PUBLICATION INDEX FOR SGS 1-34

K & L SOARING, LLC
5996 STATE ROUTE 224
CAYUTA, NY 14824

BULLETIN NO. SA-001.6*

SUBJECT: ONE-TIME INSPECTION OF TOW RELEASE ASSEMBLY; DAILY INSPECTION OF TOW RELEASE ASSEMBLY; PILOT'S PREFLIGHT INSPECTION OF TOW RELEASE ASSEMBLY; 100 HOUR/ANNUAL INSPECTION OF TOW RELEASE ASSEMBLY.

FIGURE 1 – ENGAGEMENT OF TOW HOOK INTO RELEASE ARM

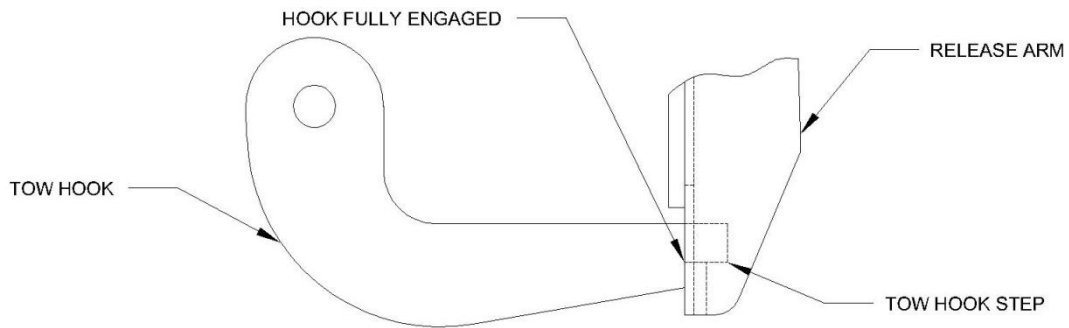
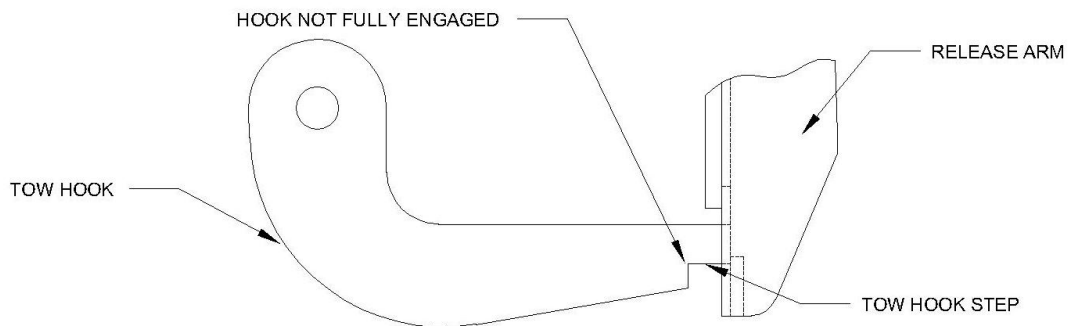
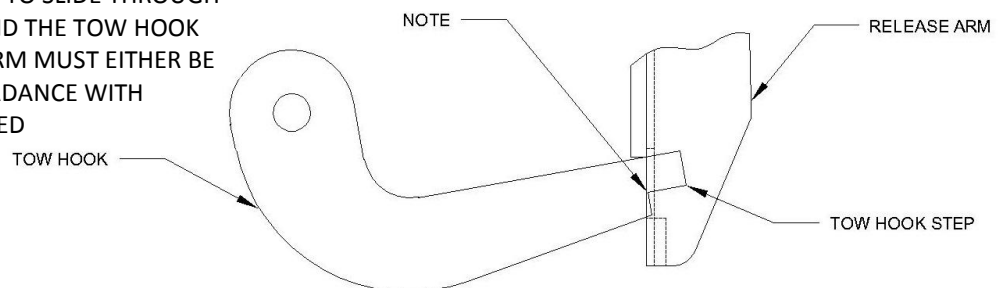
OVERVIEW: The .5 revision is the same as the .4 revision except changes to Figures 1, 3, & 4. Figure 1 has changed to add View D to show improper engagement. Figure 3 has been changed to show proper release arm cutout. Figure 4 has been changed to show proper readings for the C.G. hook install.

- Figure 1 shows the proper attachment of the tow hook into the release arm. Note that the step of the tow hook should seat against the release arm. The tow hook step must fully engage the release arm to allow the release assembly to function properly. The tow hook must not be allowed to extend through the release arm beyond the step on the hook as shown in Figure 1, View C.

IF TOW HOOK IS ABLE TO SLIDE THROUGH RELEASE ARM, BEYOND THE TOW HOOK STEP, THE RELEASE ARM MUST EITHER BE REWORKED IN ACCORDANCE WITH FIGURE 3, OR REPLACED

- d. If tow hook dimensions are not within limits specified in Figure 2, either rework the tow hook to obtain dimensions (as specified in Figure 2) or replace it with a new or serviceable, used tow hook
- e. Engage tow hook into release arm. Ensure that the tow hook properly engages as shown in Figure 1, View A.
- f. If tow hook is unable to completely engage (shown by Figure 1, View B) shorten the rubber bumper stop between the release knob and the instrument panel to allow the release assembly to close further.

- g. If tow hook is able to travel too far inboard as shown in Figure 1, View C, disengage tow hook from release arm and measure the length of the release arm slot
- h. If dimension is less than 0.66 inch, rework release arm by welding on 1B-217-19 slug at location shown in Figure 3. (Release arm may be replaced as an alternate to welding on slug)
- i. If length of release arm slot is greater than 0.66 inch, replace release arm.
- j. Perform a thorough inspection of the tow hook installation in accordance with the 100 hour inspection requirements listed in Table 2 of this bulletin.
- k. Repair or replace unserviceable component(s), as required
- l. Record compliance with Part I of this Service Bulletin in Aircraft Log Book.

FIGURE 2 – TOW HOOK INSPECTION AND REWORK (SHEET 1 OF 2)

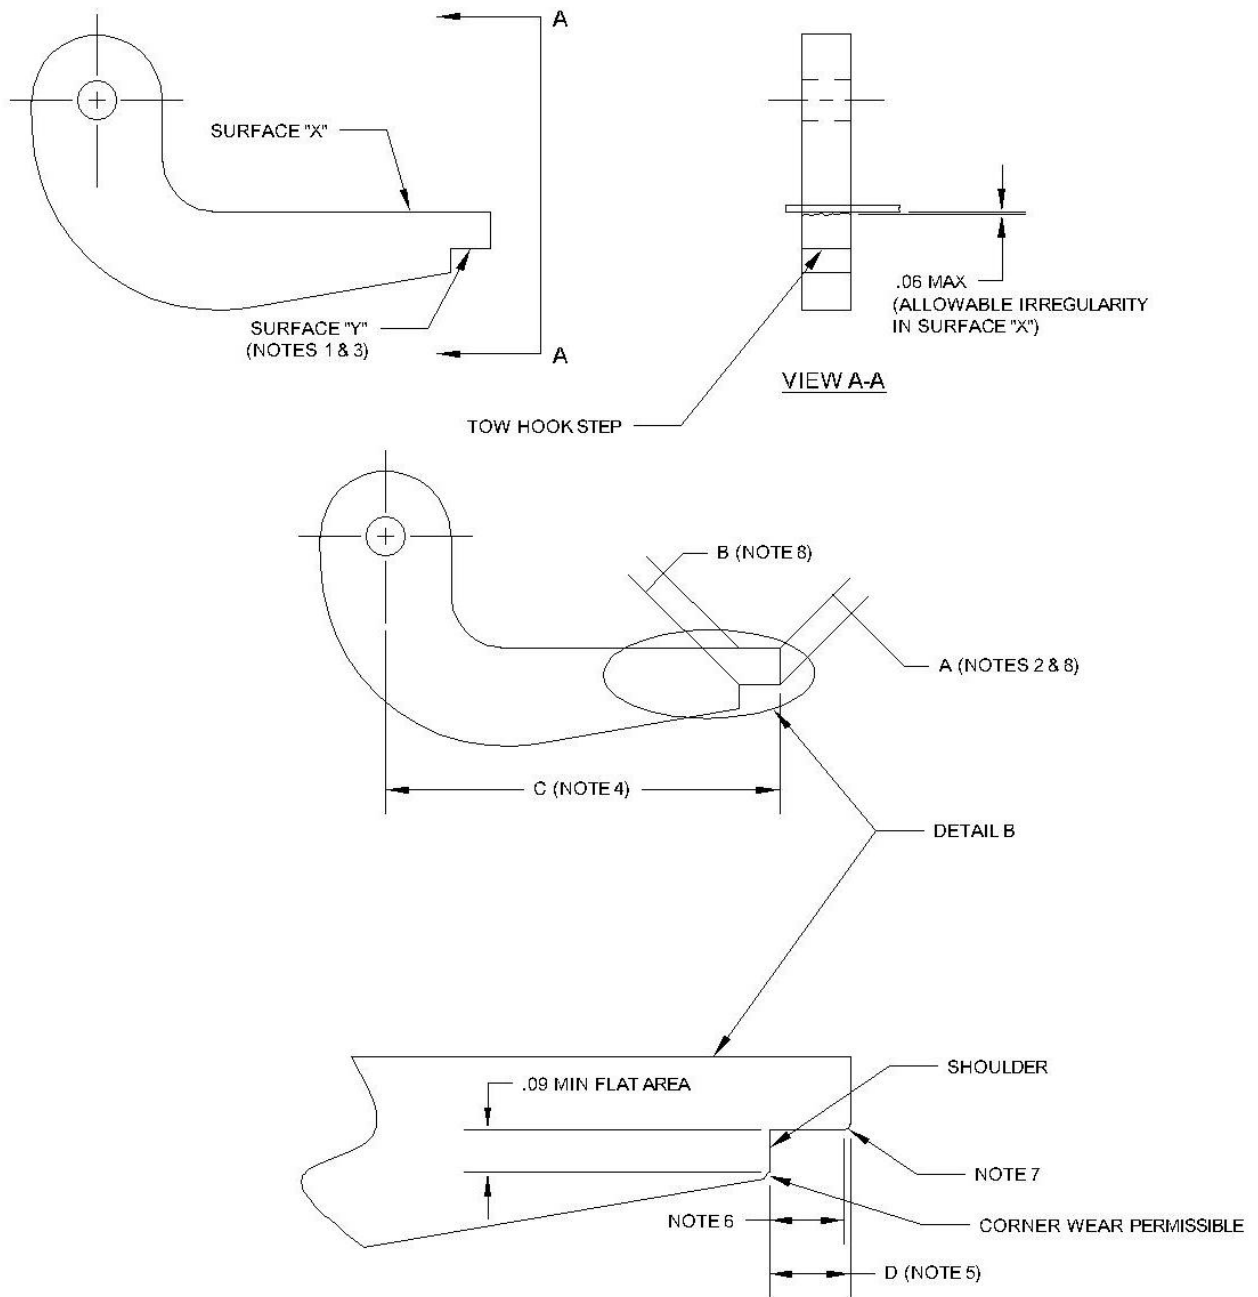
- Proper engagement of the tow hook into the release arm is shown in Figure 1, View A, and Figure 4. Excessive wear of the tow hook step could result in improper engagement. Figure 2 of this bulletin provides inspection data and wear limits for the tow hook. Tow hooks which do not meet the specified limits must either be reworked to obtain dimensions (as specified in Figure 2) or replaced.
 - If tow hooks is able to slide into the release arm, beyond the tow hook step, as shown by Figure 1, View C, the release arm must either be reworked with a slug as specified in Figure 3, or replaced.
- c. Inspect tow hook for wear in accordance with Figure 2 of this bulletin.

1. IF WEAR OCCURS ON SURFACE "Y" IT MUST BE POLISHED FLAT WITHIN TOLERANCES PROVIDED IN FIGURE 2 (SHEET 1). IF THE HOOK CANNOT MEET THESE REQUIRED DIMENSIONS IT MUST BE REPLACED. UNDER NO CONDITIONS SHOULD SURFACE "X" BE POLISHED OR MACHINED TO CHANGE ITS ANGLE.

2. DIMENSION "A" ON STD 10232-001 HOOK SHALL BE .21 INCHES MIN. & .28 INCHES MAX. DIMENSION "A" ON STD 1A218-1A, STD 1B221-3, & R-200-9A HOOKS SHALL BE .25 INCHES MIN. & .31 INCHES MAX.

3. SURFACE "Y" MUST REMAIN FLAT, SMOOTH, AND WITHIN TOLERANCES SHOWN ON SHEET 1. (SEE ILLUSTRATION).
4. DIMENSION "C" ON STD 10232-001 HOOK SHALL BE $2.06 \pm .03$ INCHES. DIMENSION "C" ON STD 1A218-1A, STD 1B221-3, & R-200-9A SHALL BE $3.00 \pm .03$ INCHES.

5. DIMENSION "D" ON STD 10232-001 HOOK SHALL BE $.25 \pm .03$ INCHES. DIMENSION "D" ON STD 1A218-1A, STD 1B221-3, & R-200-9A SHALL BE $.31 \pm .03$ INCHES.

6. HOOK MUST REMAIN FLAT IN THIS AREA FOR A MIN. OF .21 INCHES FROM SHOULDER OF HOOK.
7. WEAR OUTSIDE OF THE .21 MIN. FLAT AREA IS PERMISSABLE.
8. DIMENSION "B" MUST BE EQUAL TO DIMENSION "A", OR LESS THAN DIMENSION "A" BY NO MORE THAN .015 INCHES AND CANNOT BE GREATER THAN DIMENSION "A".

FIGURE 3 - REWORK OF RELEASE ARM

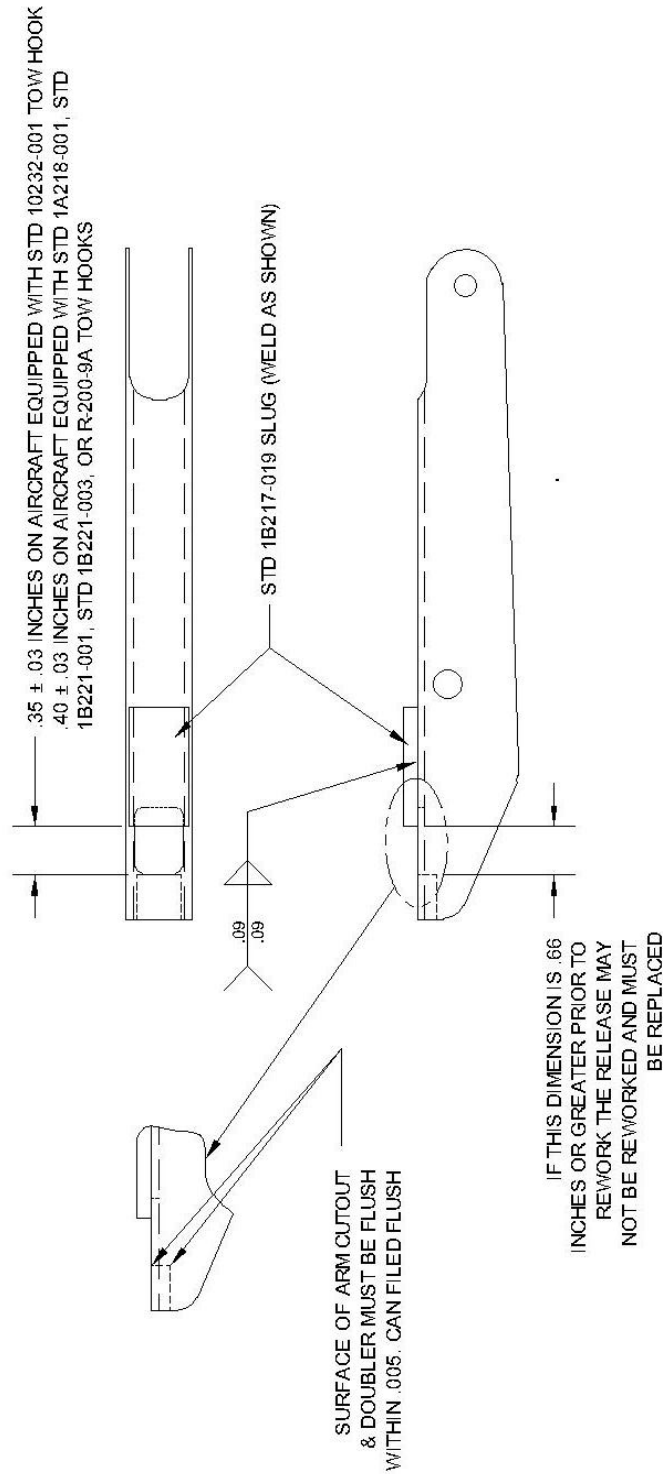
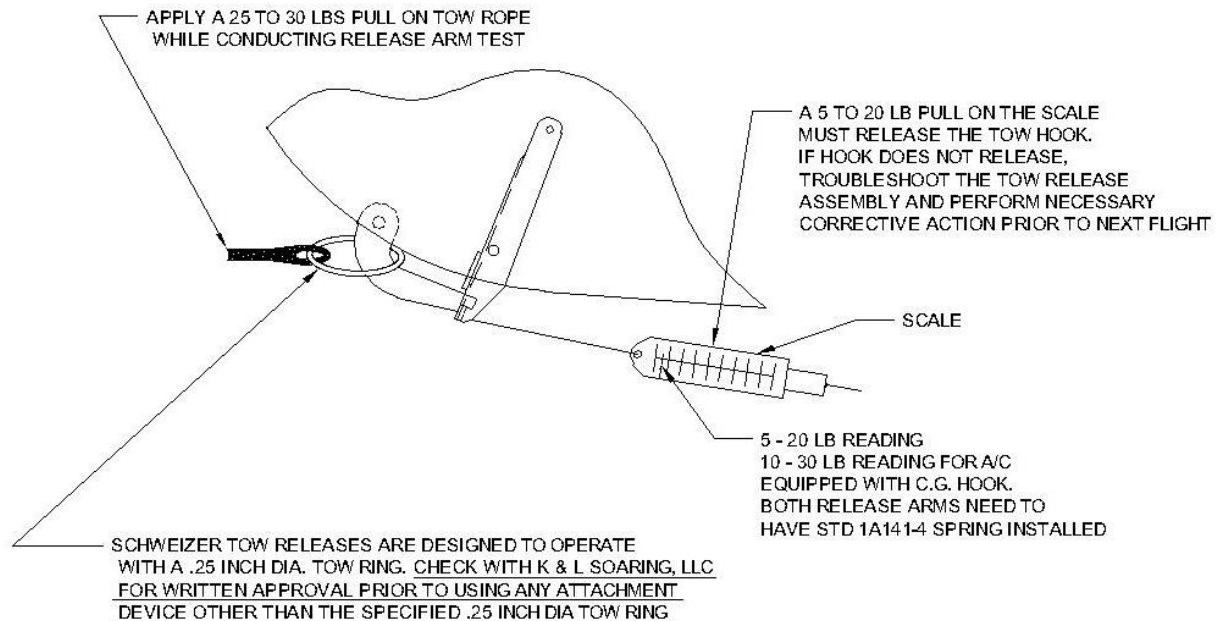
NOTE: STD 1B217-019 SLUG IS AVAILABLE FROM K & L SOARING, LLC
0.125 X 0.5 X 1.0 4130N STEEL

NOTE: ALL TOW RELEASE ARMS MUST BE REWORKED AS SHOWN ABOVE OR REPLACED WITH THE PROPER SUPERSEDING ARM AS SPECIFIED IN TABLE 1

FIGURE 4 - PULL TEST OF TOW RELEASE ASSEMBLY

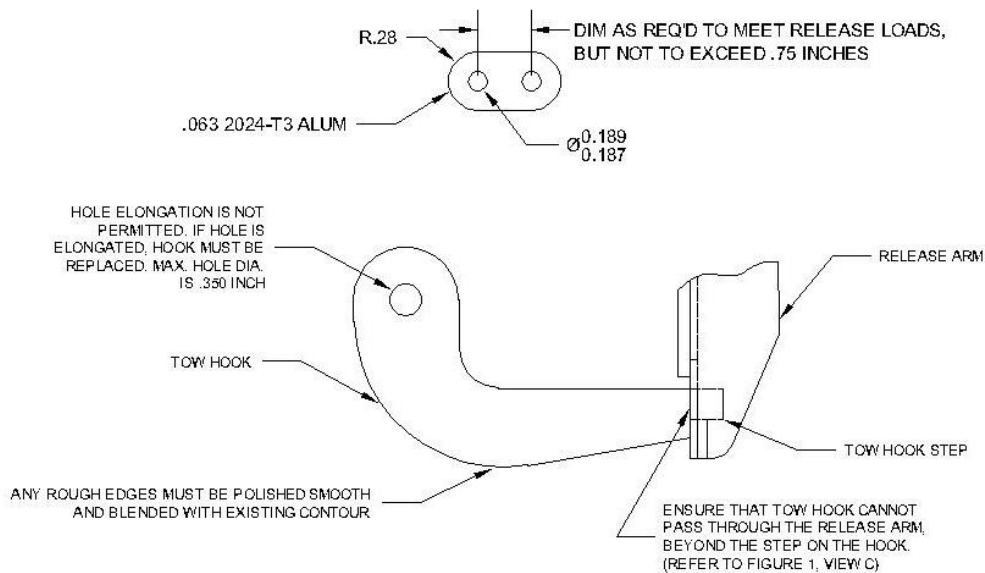
NOTE: IF RELEASE LOADS ARE TOO HIGH WITH C.G. SYSTEM IT IS PERMISSIBLE TO ADD A LINK TO SHORTEN STD 1A141-2 SPRING. LINK SHOULD BE MADE AS SHOWN BELOW. IF REQUIRED THEY SHOULD BE ADDED TO BOTH RELEASE ARMS TO BALANCE BOTH RELEASE SPRINGS

Perform a release check for proper release tension in accordance with Figure 4.			X
Lubricate attach hardware for tow hook and release arm.		X	X
Lubricate guide-tubes in release control with dry stick type lubricant.		X	X
Insure that tow hook moves freely on pivot bolt.	X	X	X

Figure SA-012-1. Seat Pan in Normal Position (Bottom Seat Cushion Removed)

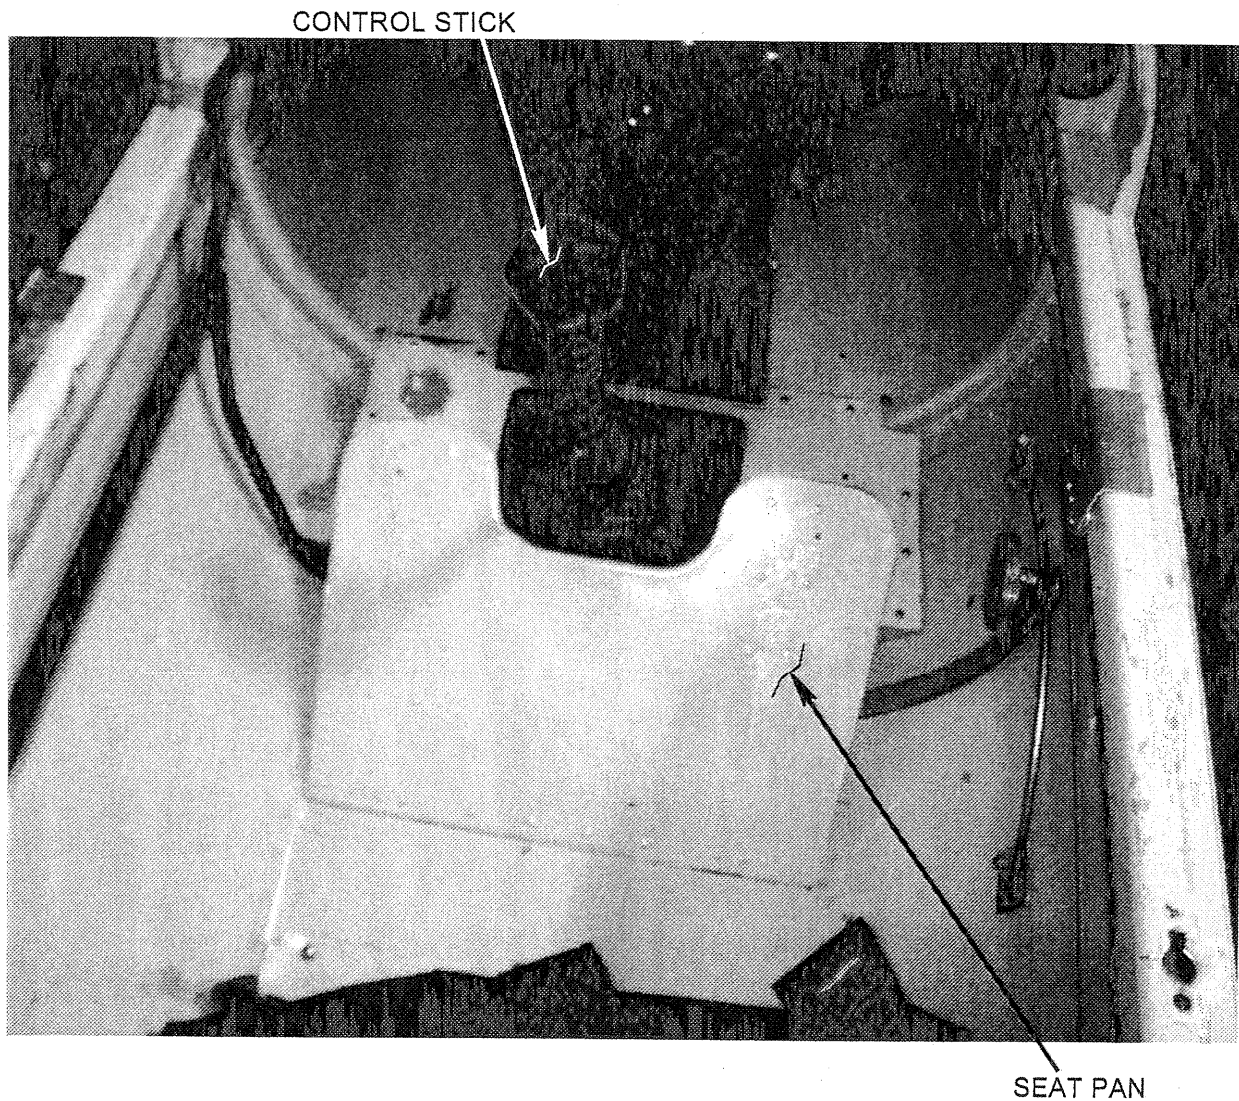
- Remove the bottom seat cushion to gain access to the seat pan (Fig. SA-012-1).
- Raise the seat pan to a partially open position and observe that the lower hinge half is positioned forward of the hinge pin as shown on Fig. SA-012-2, Detail A. This is the correct orientation. (If the lower hinge half is positioned aft as shown on Detail B, the seat pan is in the wrong location and this condition must be corrected before further flight.)
- With the seat pan raised, check the control stick/elevator range of motion; perform the same check with the seat pan in normal (down) position. Verify that range of motion is not affected by seat pan position.

Figure SA-012-2. Seat Pan in Raised Position

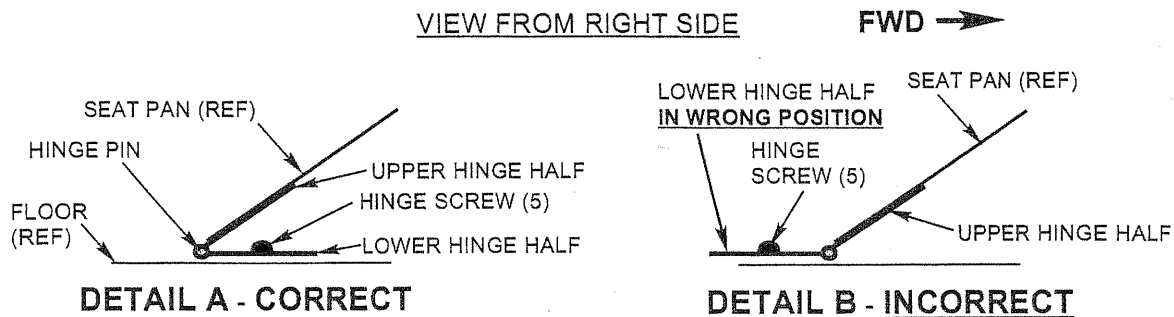
INSTALL "SEAT PAN"
PLACARD AT THIS
LOCATION

- c. Install the "CAUTION" placard on hinge as shown on Fig. SA-012-3. Install the "SEAT PAN" placard as shown on Fig. SA-012-2.
- d. Using five hinge screws, re-install the seat pan with the "CAUTION" placard facing downward.
- e. Perform steps b. and c. of PART I to verify that seat pan is installed correctly.
- f. Record compliance with this Bulletin in the aircraft records.

Figure SA-012-3. Seat Pan on Work Surface

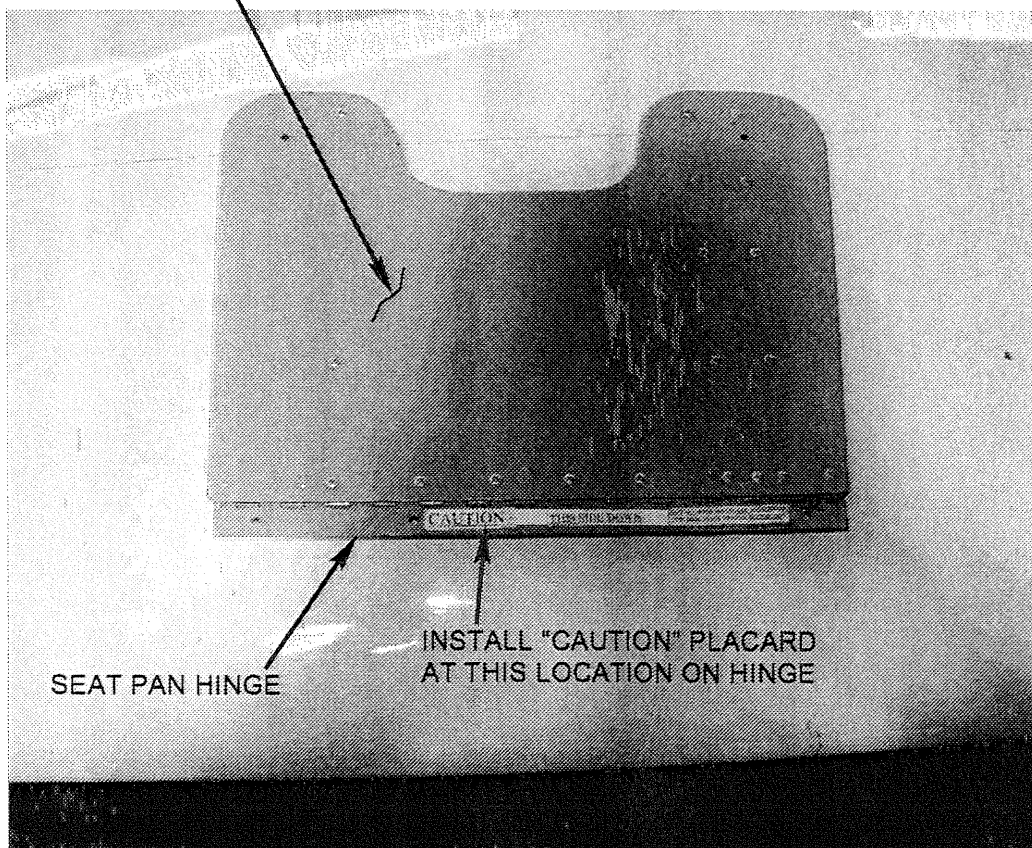
- a. Raise seat pan and remove five hinge screws; remove seat pan (Fig. SA-012-2).
- b. Using scissors or sharp knife, cut the "CAUTION" and "SEAT PAN" placards from Fig. SA-012-3.

INSTALL "CAUTION" PLACARD
AT THIS LOCATION ON HINGE
